## SERVICE BULLETIN

EL14-008a

### 2013-2014 PATHFINDER; PARKING SENSOR ERROR DISPLAYED ON METER AT TEMPERATURE BELOW 5°F

Figure 1

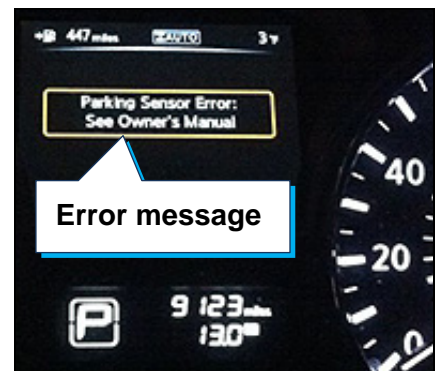
- The message "Parking Sensor Error" is displayed in the vehicle's meter after cranking or starting the engine.
- Only occurs after a vehicle has been cold soaked for several hours at an outside temperatures of -15°C (5°F) or below.
- Does not display after the vehicle warms up and the ignition has been cycled.

Replace the Sonar Control Unit.
